North Dakota Department of Transportation

ADDENDUM 2 – JOB 15

TO: All prospective bidders on project NH-1-200(073)236 and NH-1-003(048)134, Job No. 15 scheduled for the November 17, 2017 bid opening.

ND 200, Jct 14 E to W Jct 3

Plan & Profile
Sta 12574+00 to Sta 12594+00

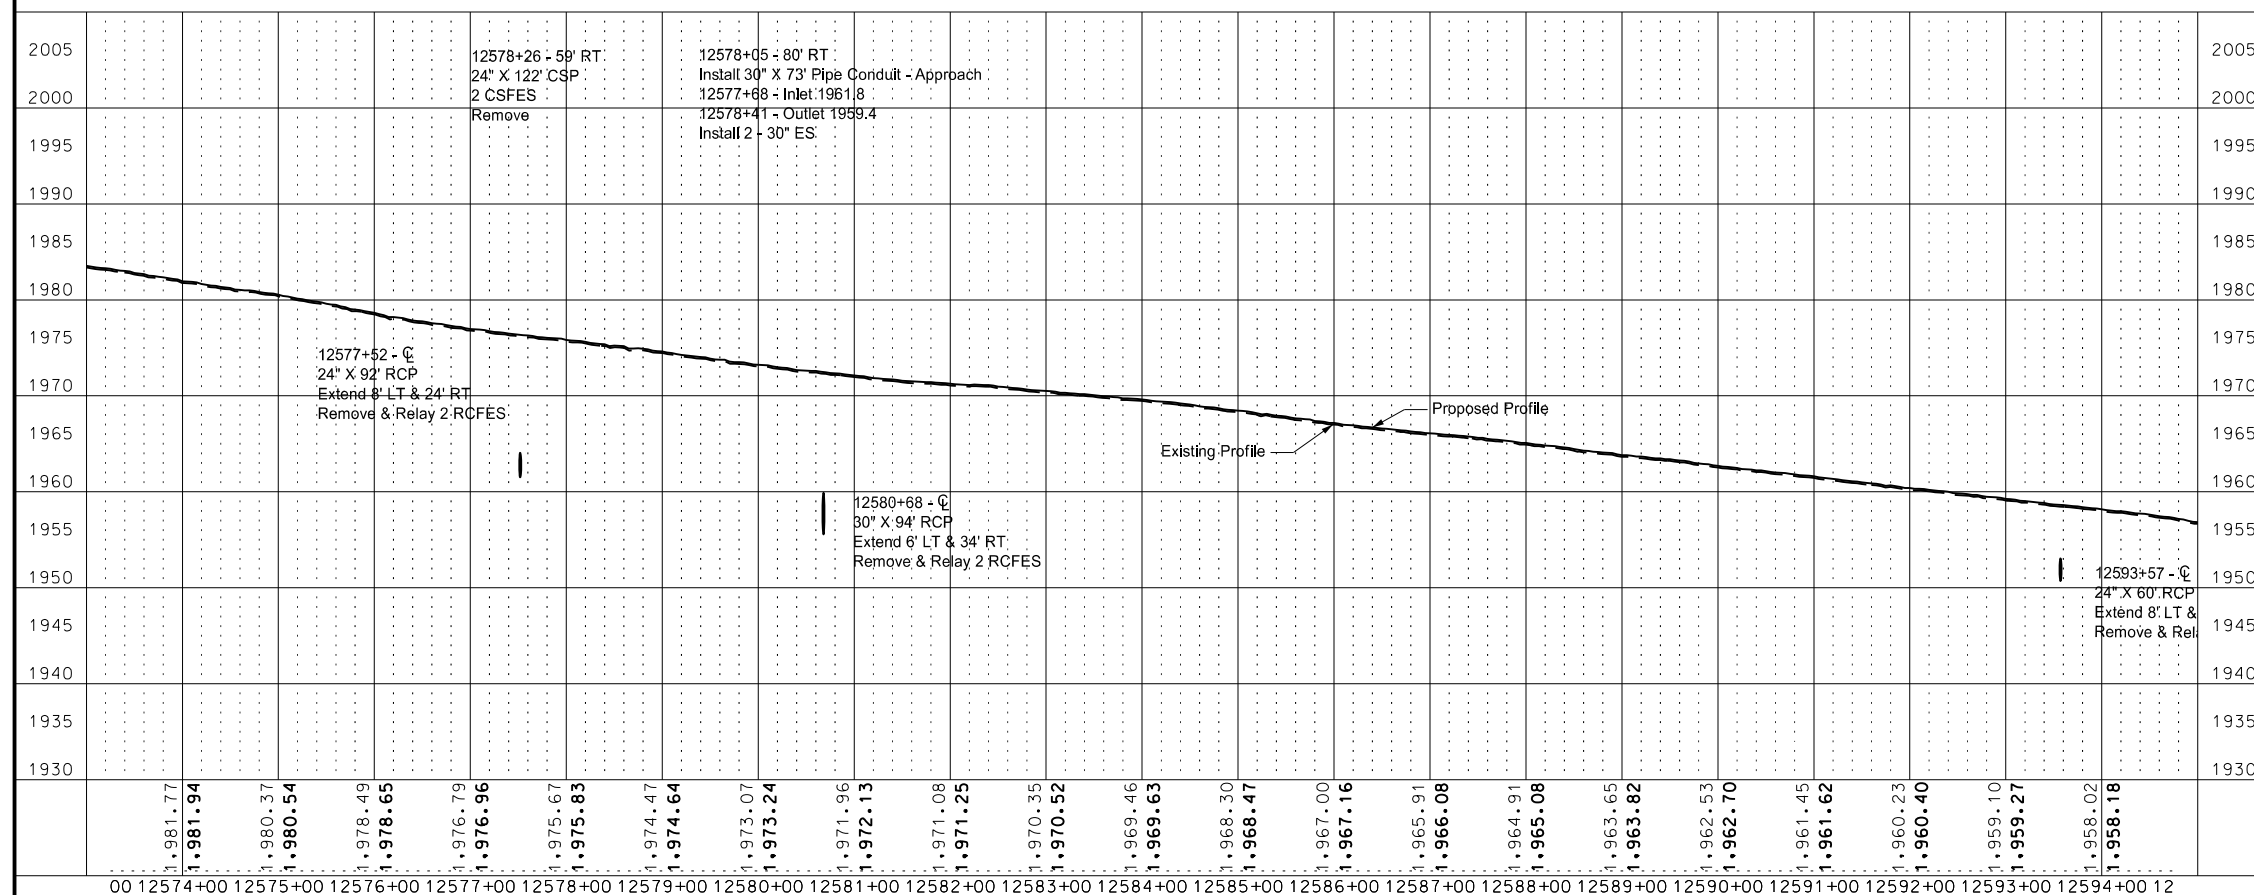
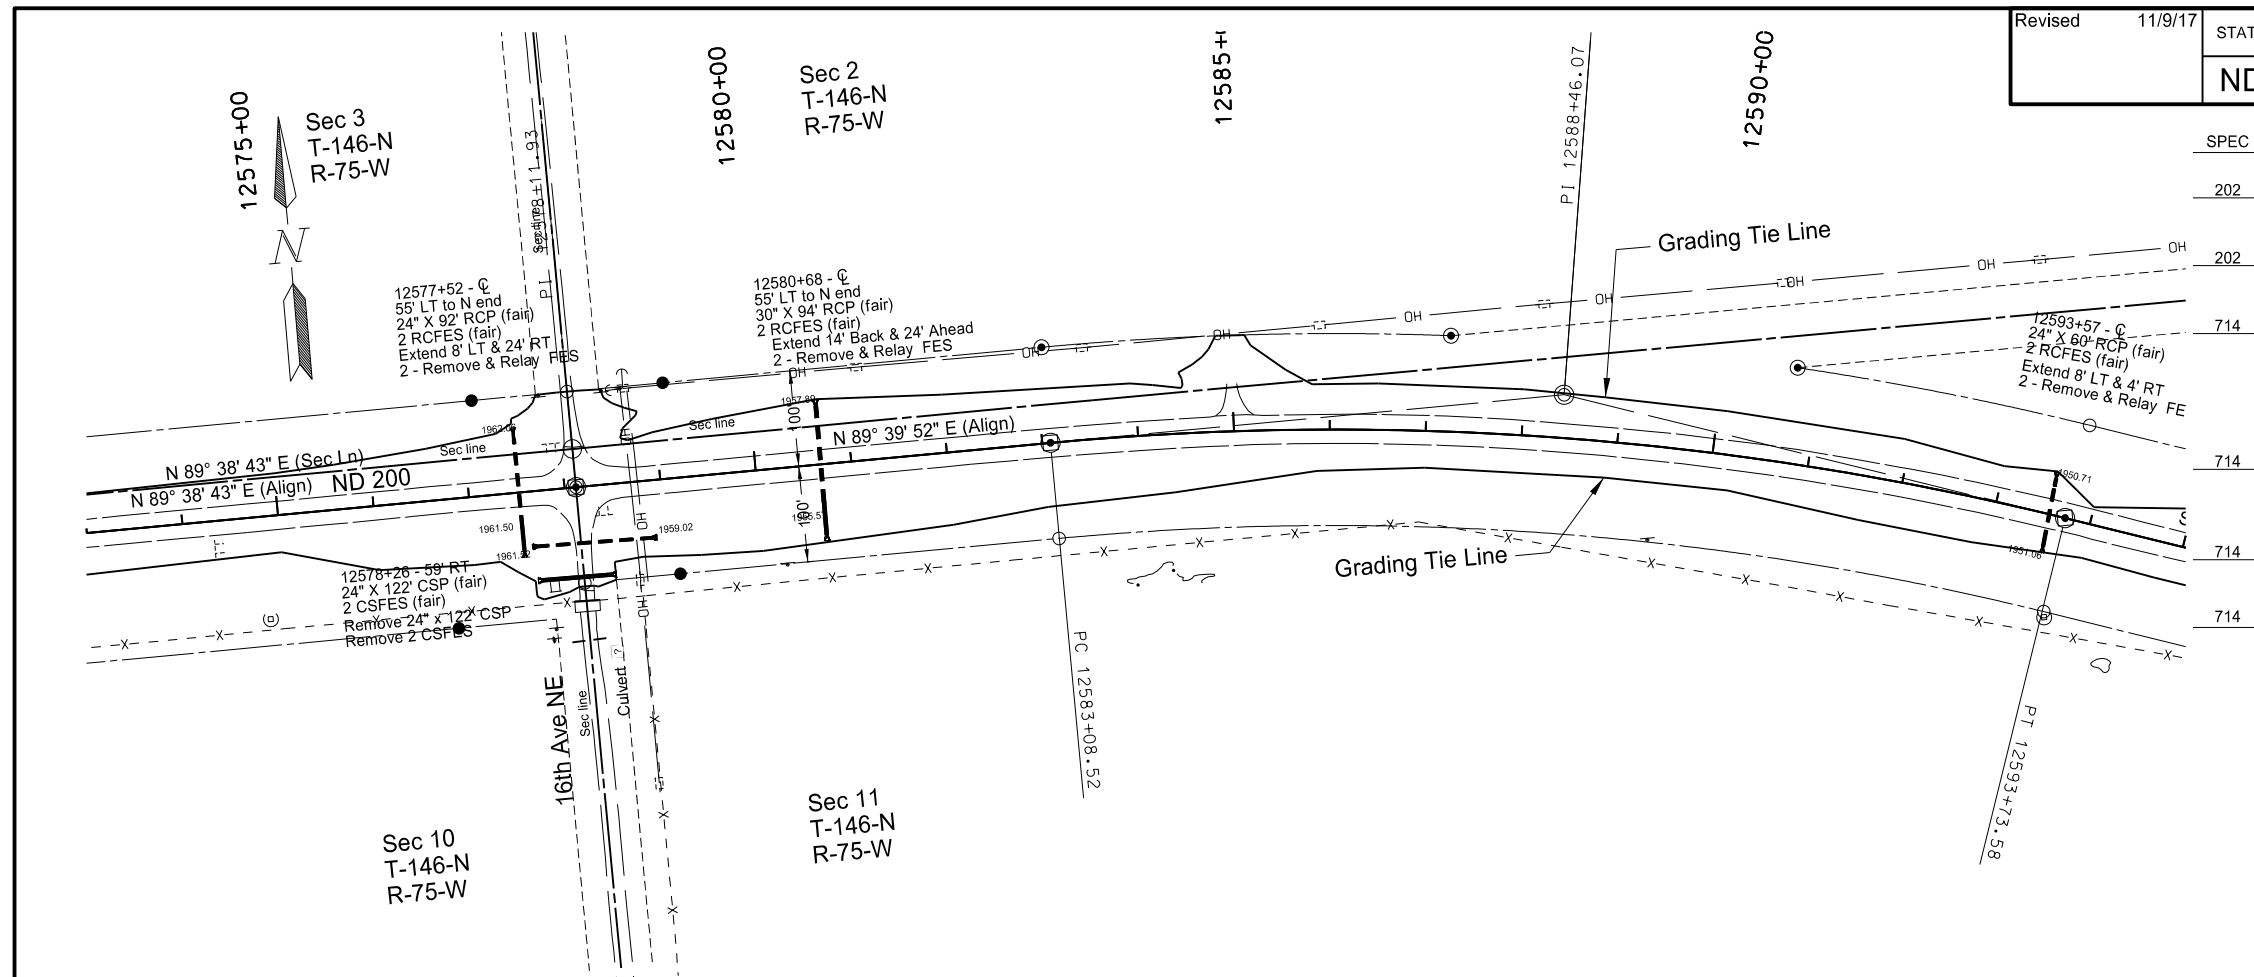
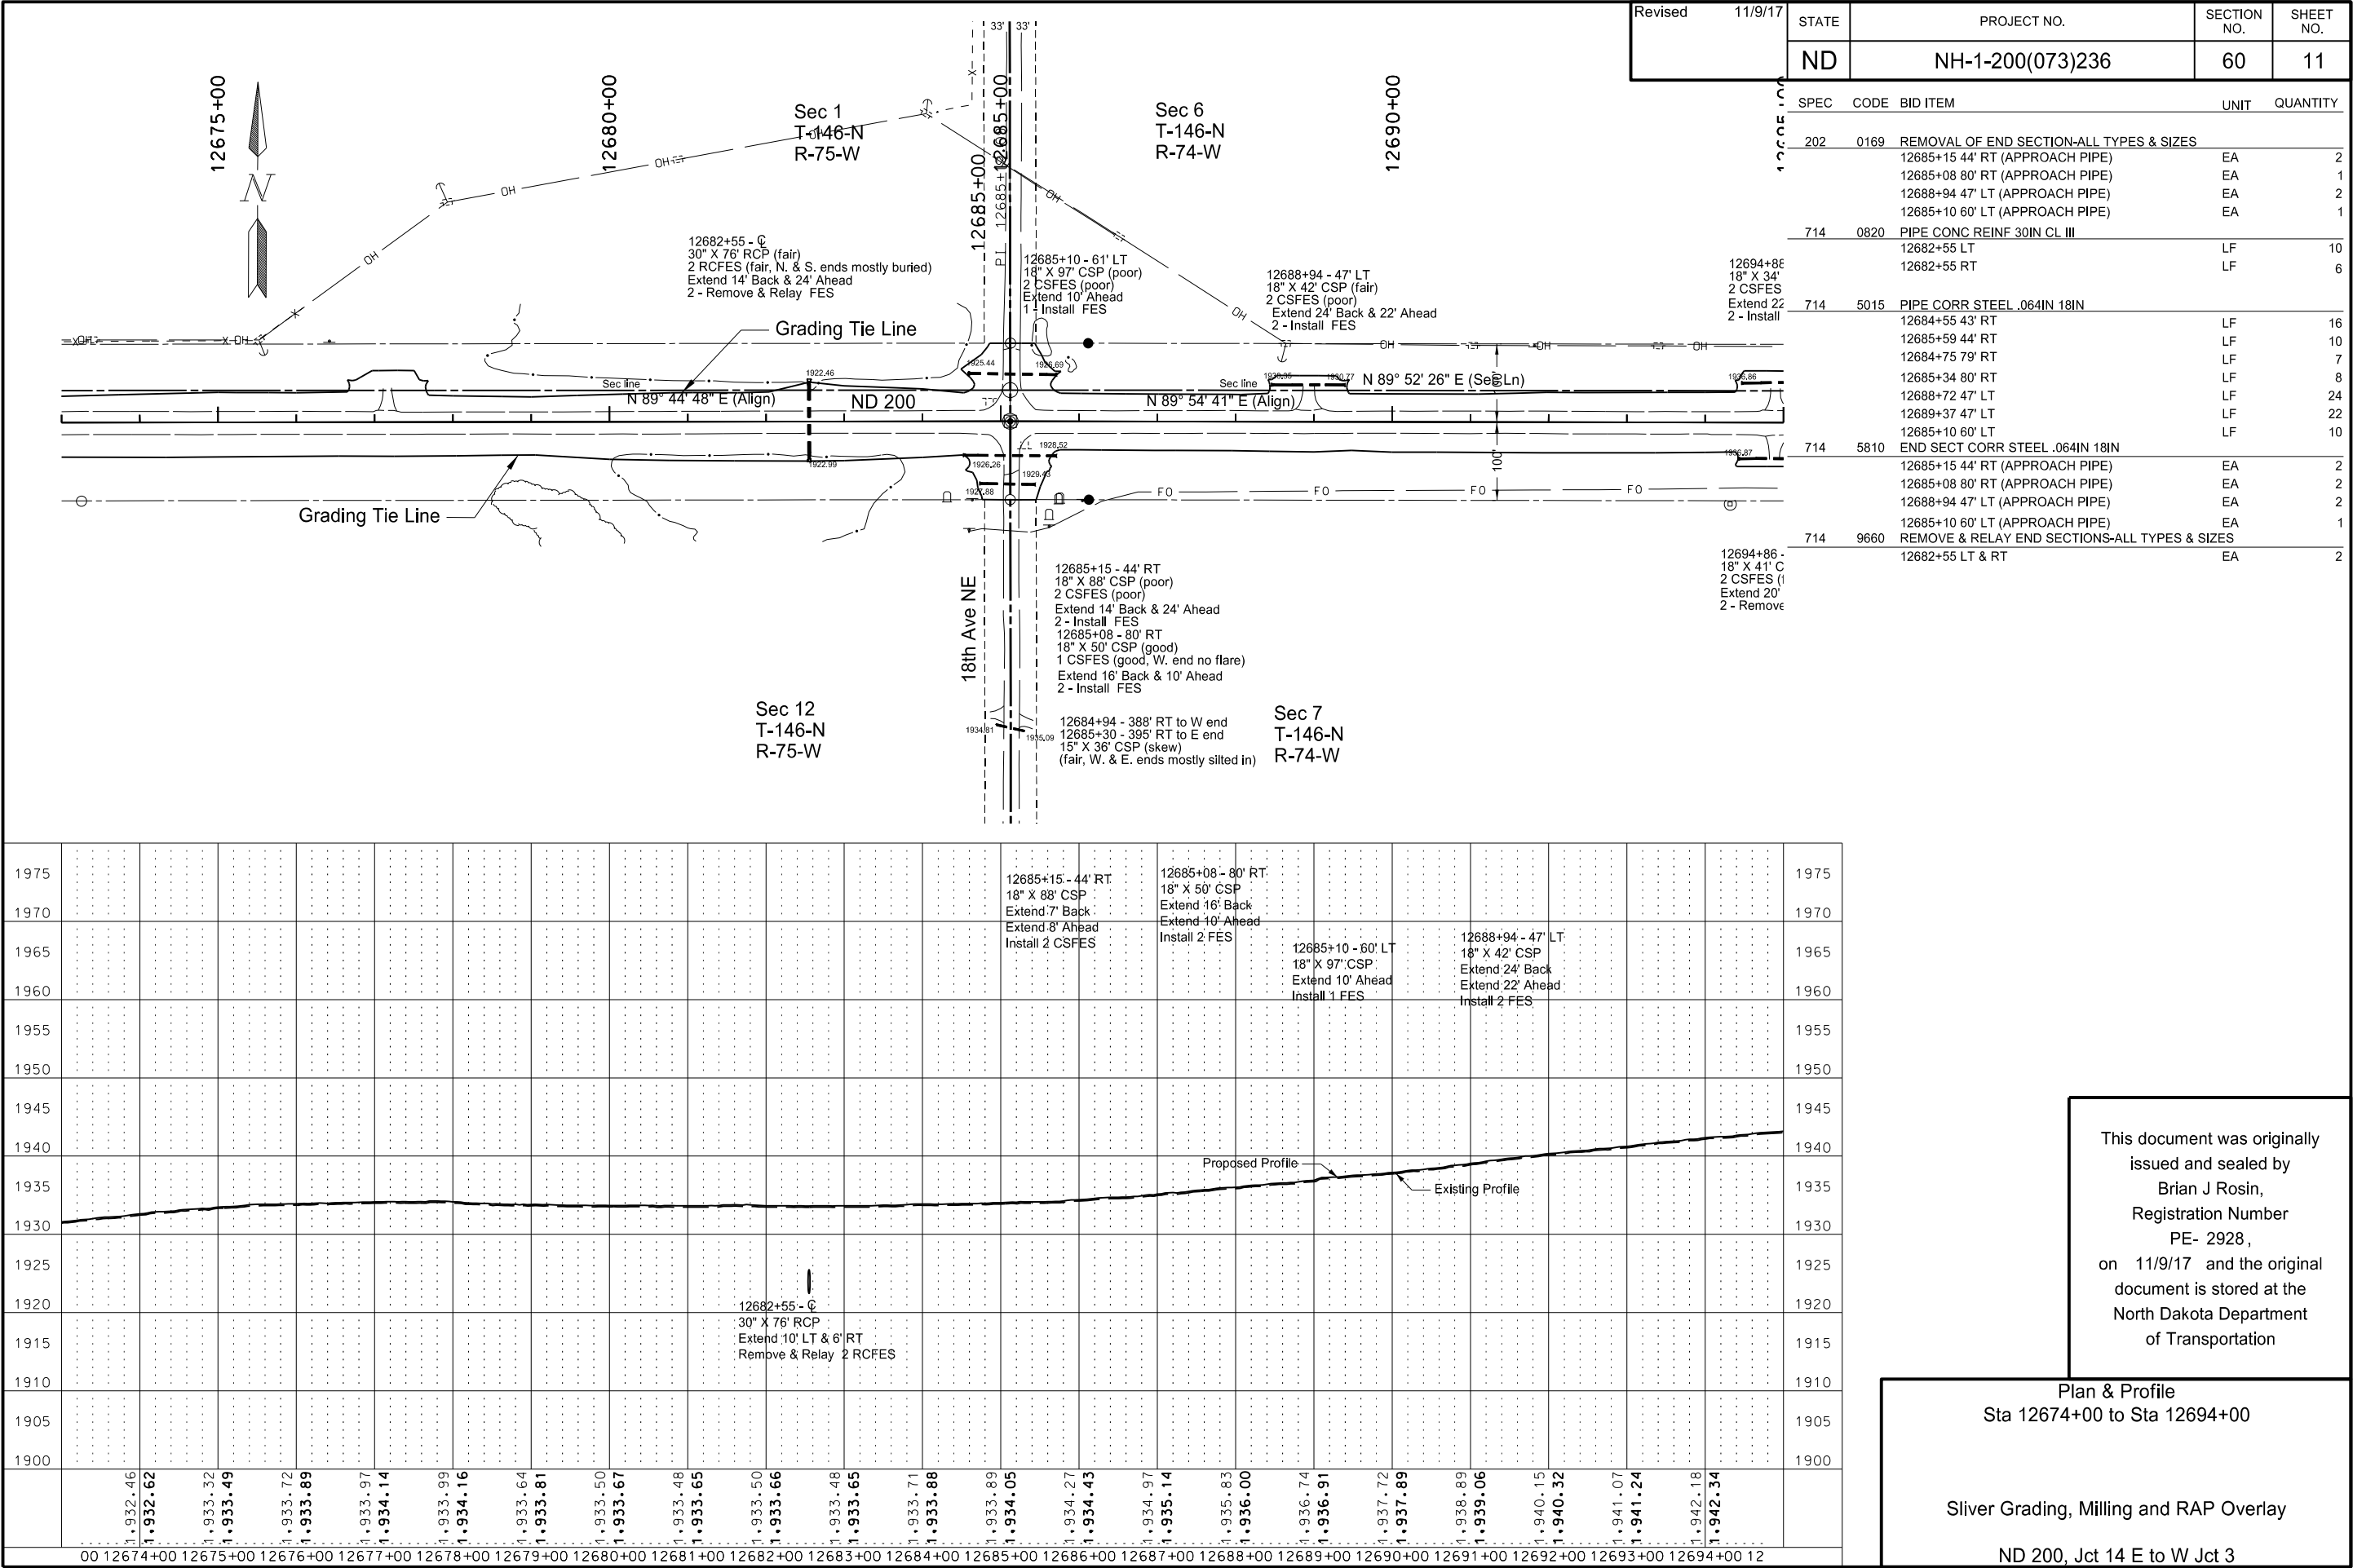
Section 60 Sheets 6, 11, 12, 15, 18, 20, 22, 23, 24, 26, 27, 28, 29, 30, 31, 34, 35, 37, 38, and 40:

Updated pipe information and quantities. Item 714 5820 was added on sheet 38.
